PCN / EOL Notification

Product Change Notification Number: CC070302A (Revised) **Date:** January 24, 2007

Title: AT24C512 DIE SHRINK

8-SOIC(1.8V)

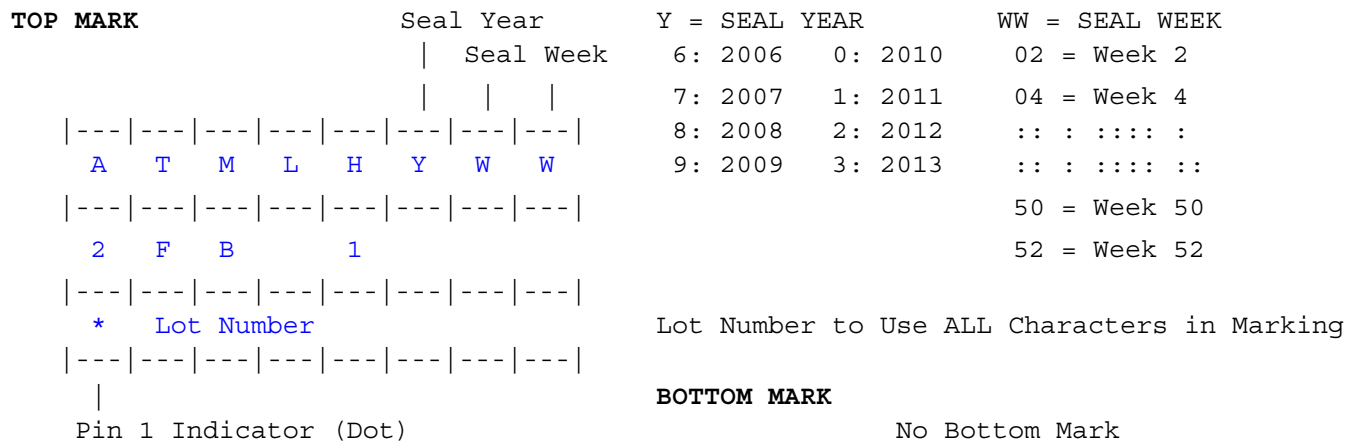
New physical part marking scheme:
